Docket Nos. 50-280  
and 50-281

Licenses Nos. DPR-32  
and DPR-37

Change No. 9

We have reviewed the reports "Fuel Densification - Surry Power Station Unit 1," "WCAP-8012, Addendum 1, dated April 1973, and "Fuel Densification - Surry Units 1 and 2 - Low Pressure Analysis," WCAP-8116, dated April 1973, which you submitted in support of your proposed changes for power escalation above 92% of rated power to 100% of rated power at a reduced primary coolant system pressure of 2000 psia.

Figure 2.1-1 Reactor Core Thermal & Hydraulic Safety Limits - Three Loop Operation, 100% Flow

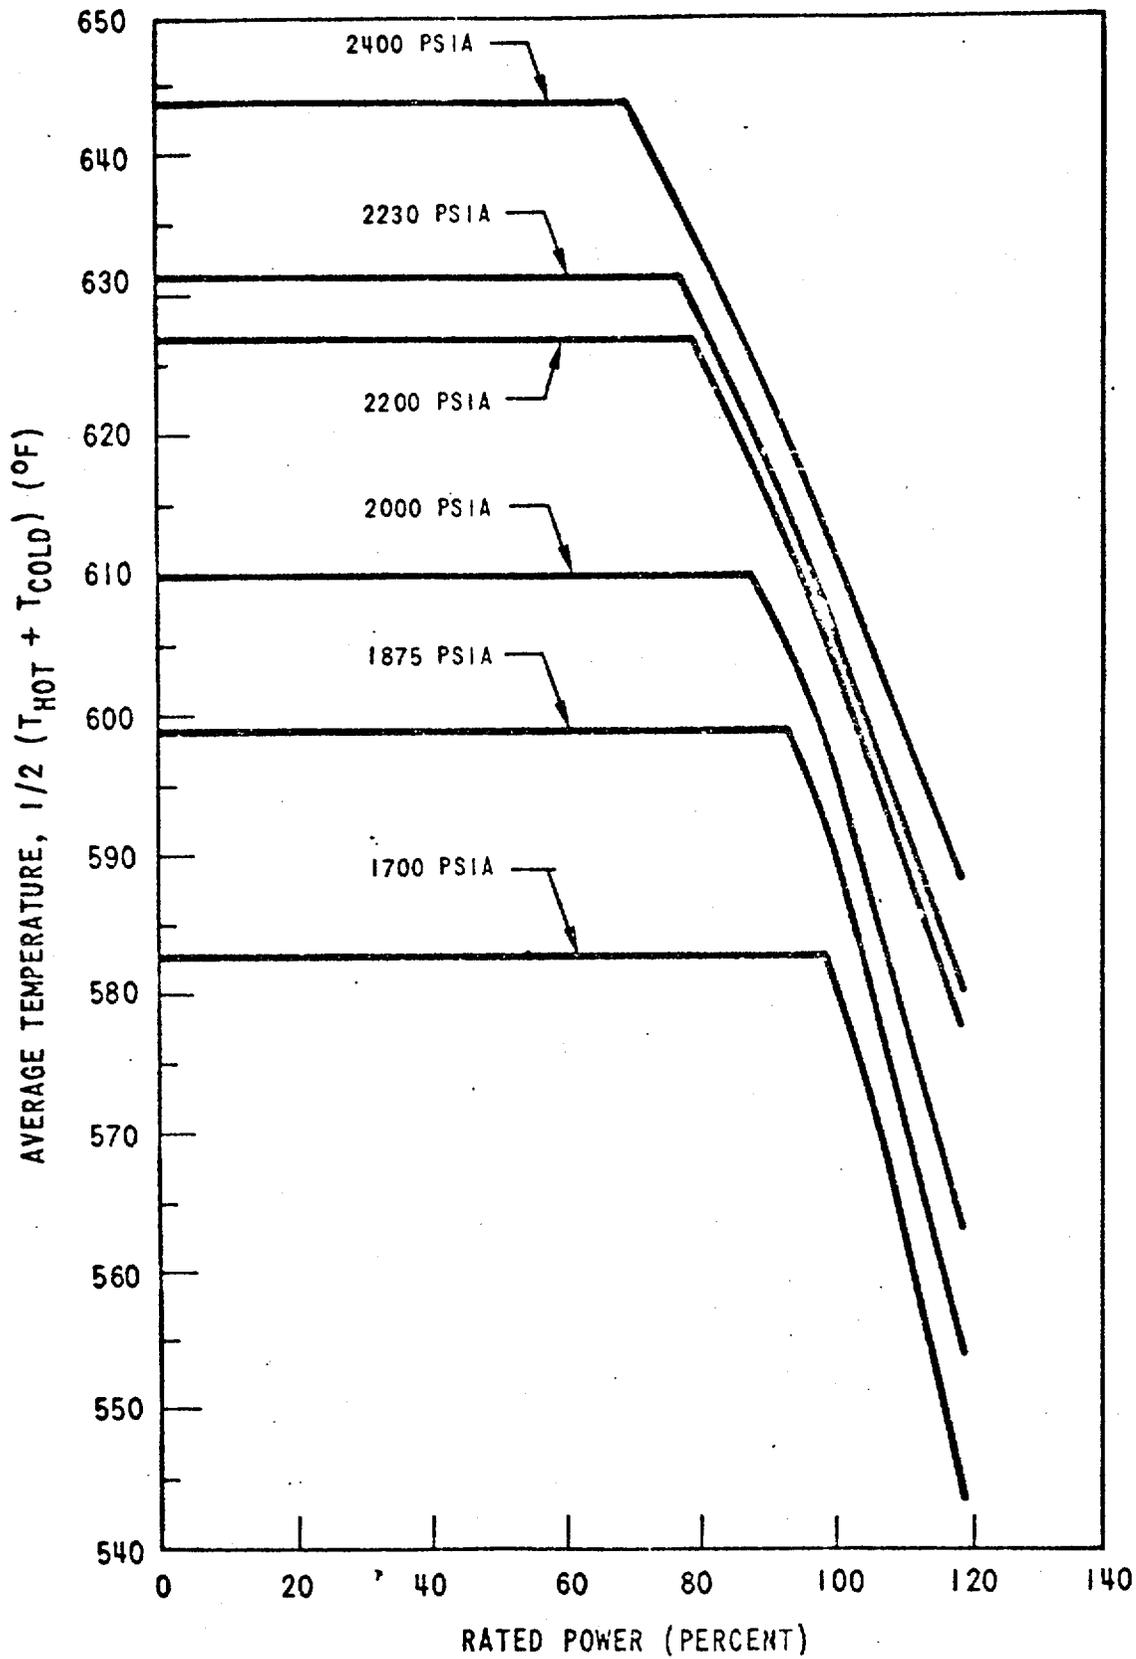
The curves of TS Figure 2.1-1 which show the allowable power level decreasing with increasing temperature at selected pressures for constant flow (three loop operation) represent the loci of points of thermal power, coolant system average temperature, and coolant system pressure for which the DNB ratio is not less than 1.30. The area where clad integrity is assured is below these lines. In order to completely specify limits at all power levels, arbitrary constant upper limits of average temperature are shown for each pressure at powers lower than approximately 75% of rated power. The temperature limits at low power are considerably more conservative than would be required if they were based upon a minimum DNB ratio of 1.30 but are such that the plant conditions required to violate the limits are precluded by the self actuated safety valves on the steam generators. The three loop operation safety limit curve has been revised to allow for heat flux peaking effects due to fuel densification.

TS Figure 2.1-2 and 2.1-3 have not been revised as these have been found to be adequate and conservative even including the effects of densification. Figure 2.1-1, 2 and 3 also include an allowance for an increase in the enthalpy rise hot channel factor at reduced power based on the expression:

Figure 2.1-4. Thermal Overpower Limit

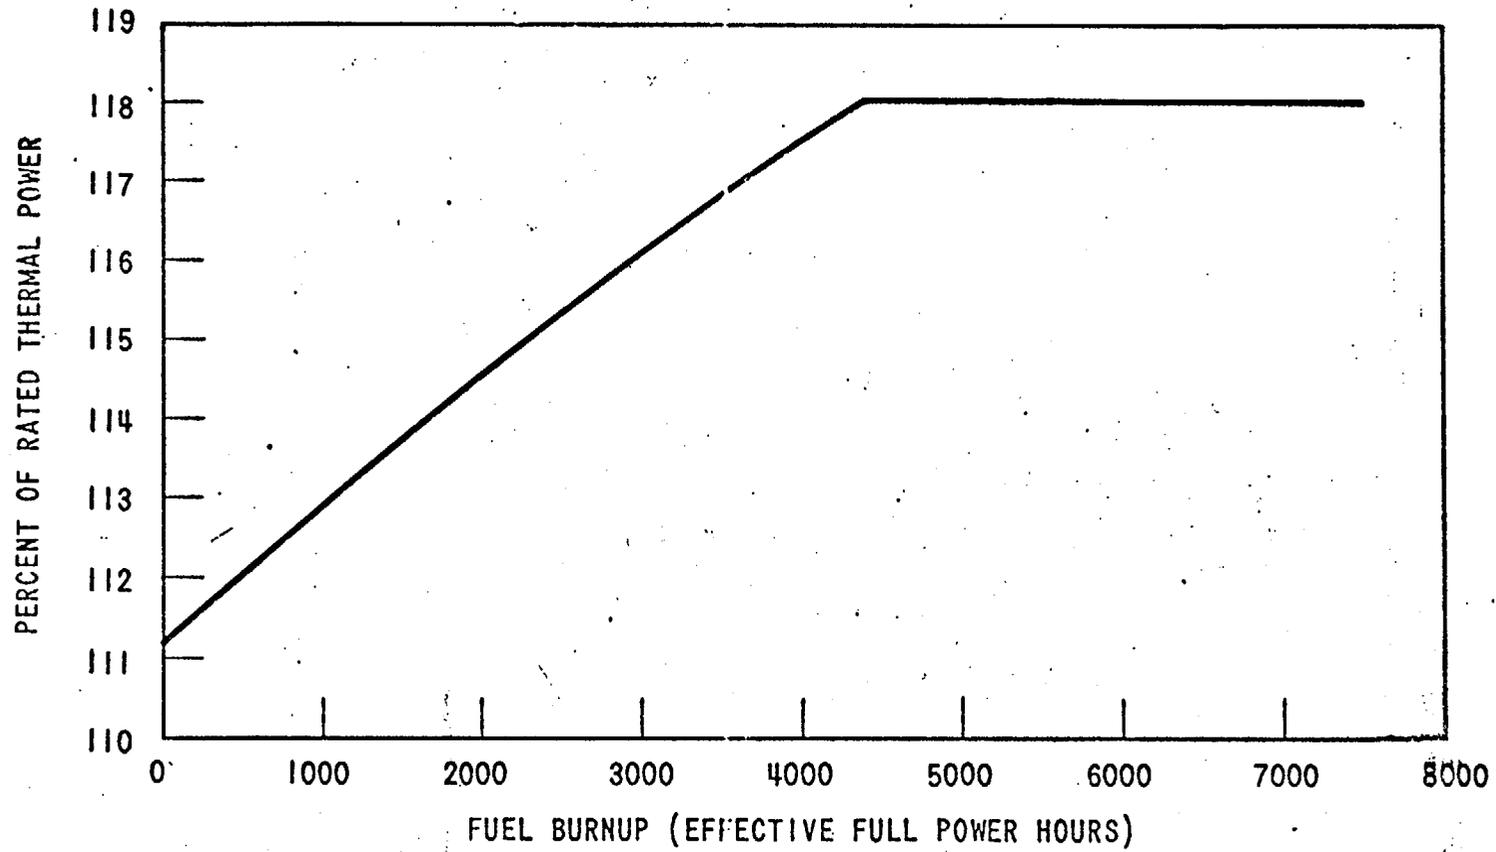
The curve of TS Figure 2.1-4 represents the fuel overpower design limit as a function of burnup. This limit is the fuel melting temperature or a linear heat rate of 21.1 kw/ft, whichever is more restrictive. Additional peaking factors to account for local peaking due to fuel rod axial gaps and reduction in fuel pellet stack length have been included in the calculation of this curve.

Figure 2.3-1. Limiting Safety System Setting for High Flux and Overpower  $\Delta T$  Trips versus Fuel Burnup

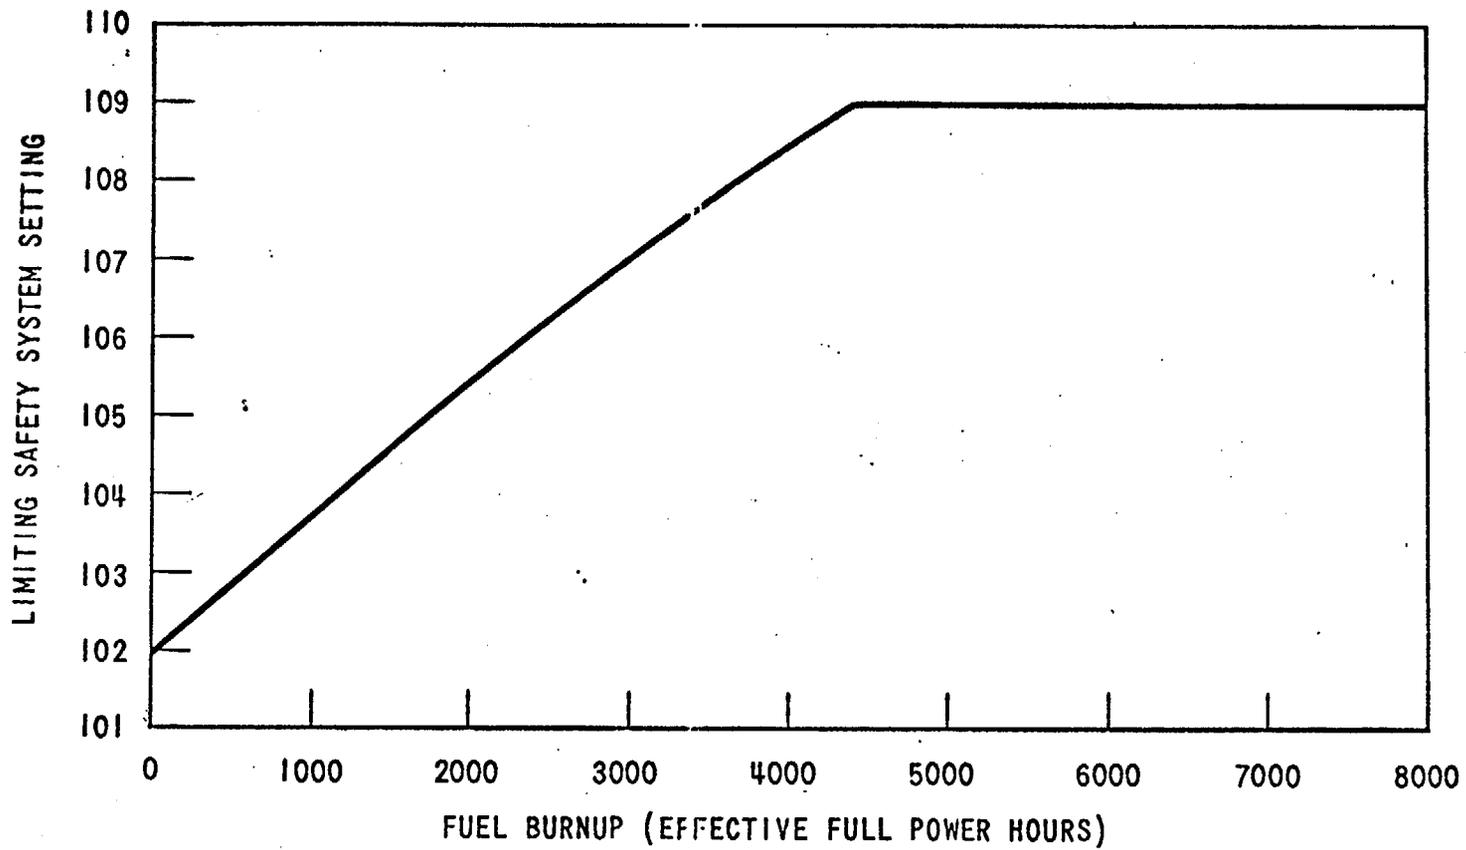
The overpower and overtemperature protection system setpoints have been revised to include effects of fuel densification on core safety limits. The revised setpoints in the Technical Specifications will ensure that the combination of power, temperature, and pressure will not exceed the revised

The reactor is prevented from reaching the overpower limit condition by action of the nuclear overpower and overpower  $\Delta T$  trips. The overpower limit criteria is that core power be prevented from reaching a value at which fuel pellet centerline melting would occur. Fuel temperature decreases due to cladding creepdown with burnup and consequential reduction of pellet-cladding gap. Thus overpower limits become less restrictive as fuel burnup proceeds and the safety system setpoints for these trips can be increased accordingly. The overpower protection system set points include the effects of fuel densification on core safety limits.

Figure 3.12-1 Control Bank Insertion Limits for Normal 3 Loop Operation

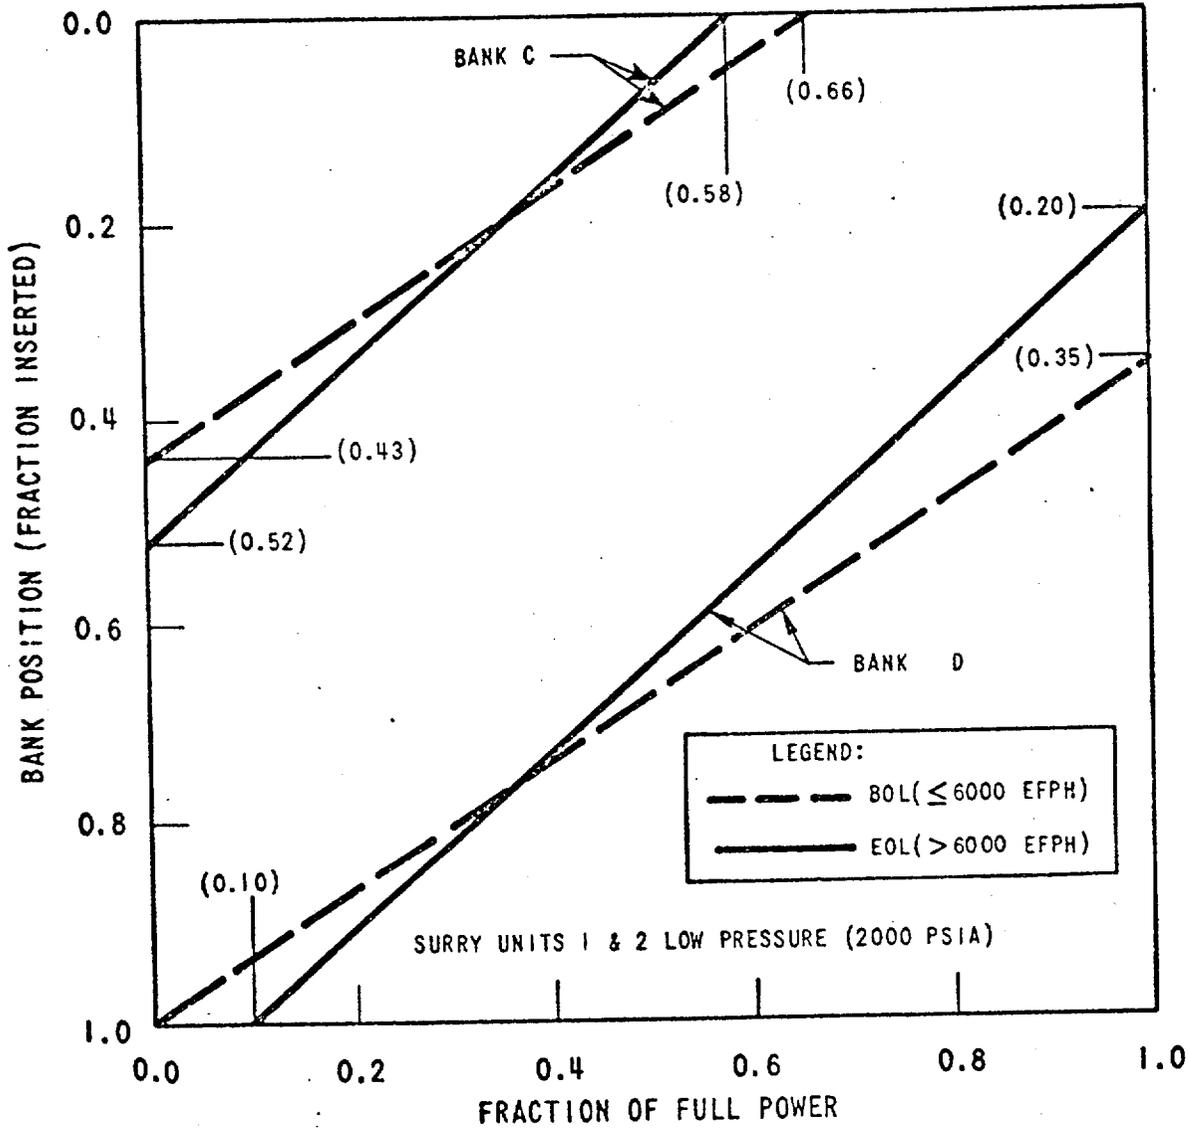
The specified control rod insertion limits have been revised to limit the potential ejected rod worth in order to account for the effects of fuel densification.

TS FIGURE 3.12-8

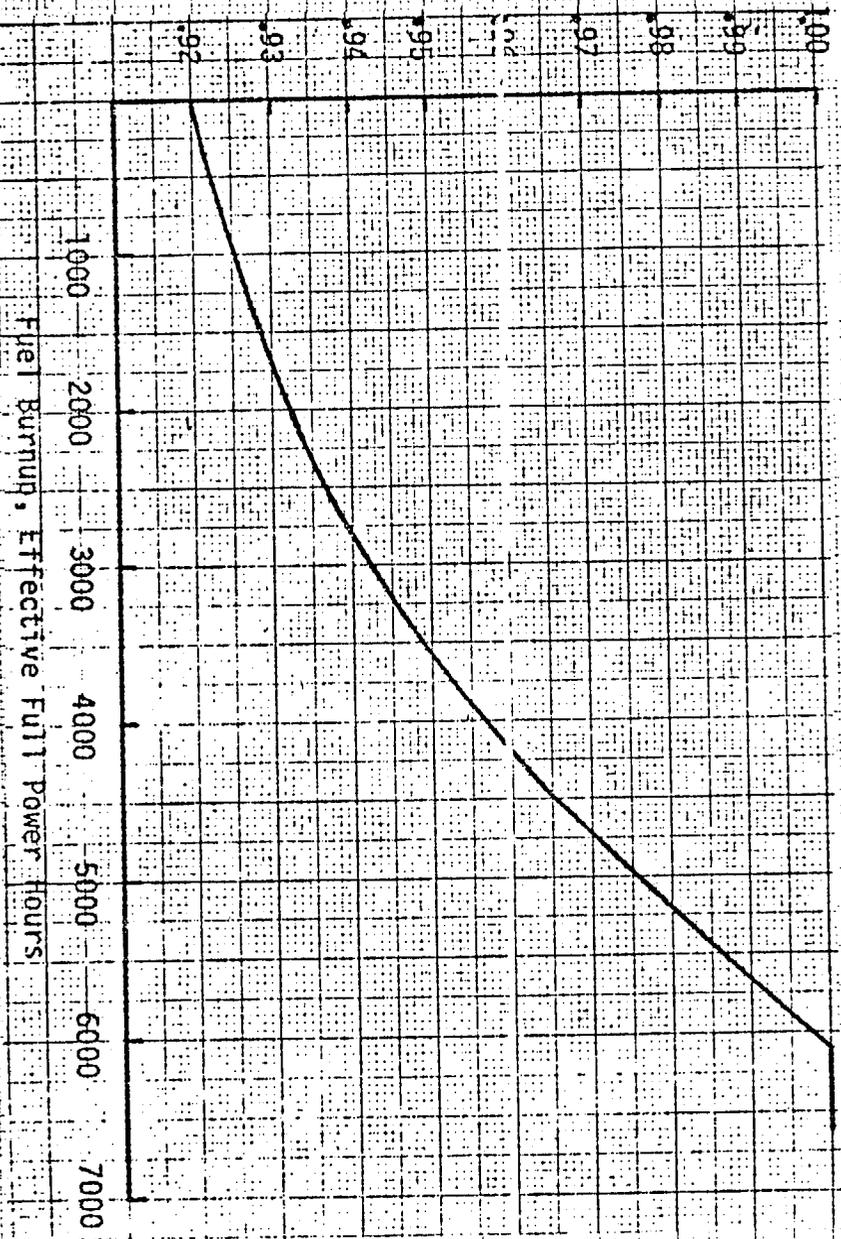
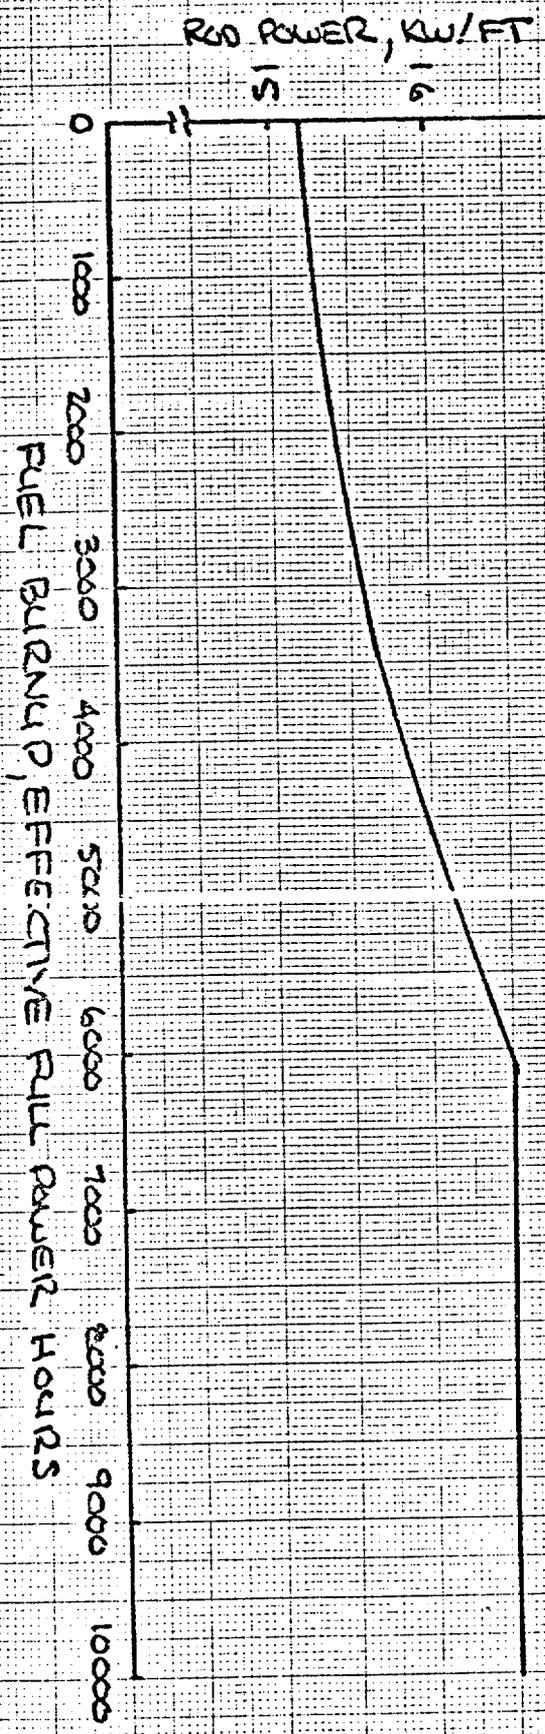
On the basis of our review, we have determined that, for this power escalation, the three areas requiring assessment were minimum DNB ratio (DNBR), stored energy, and creep collapse. The DNBR analysis was performed using the methods as described in the FSAR for 100% of rated power. The minimum value of the DNB ratio during normal operation and anticipated transients is limited to 1.30. Since the calculated DNBR is above this limit for power operation up to 100% of rated power, including anticipated transients, we find this acceptable. We have reviewed the Westinghouse time dependent creep collapse and stored energy models and find them acceptable for a fuel residence time of 10,000 EFPH. We have determined that the effects of fuel densification and reduced primary coolant system pressure above 92% of rated power have been adequately analyzed for a fuel residence time of 10,000 EFPH and that the plant power capability, with respect to such effects, is acceptably defined in Figure 3.12-8 of

the Technical Specifications and therefore, operation at 100% of rated power at a reduced primary system pressure of 2000 psia is permitted. We have also determined that the proposed incore surveillance program provides the necessary assurance that the reactor will be operated within the prescribed limits.
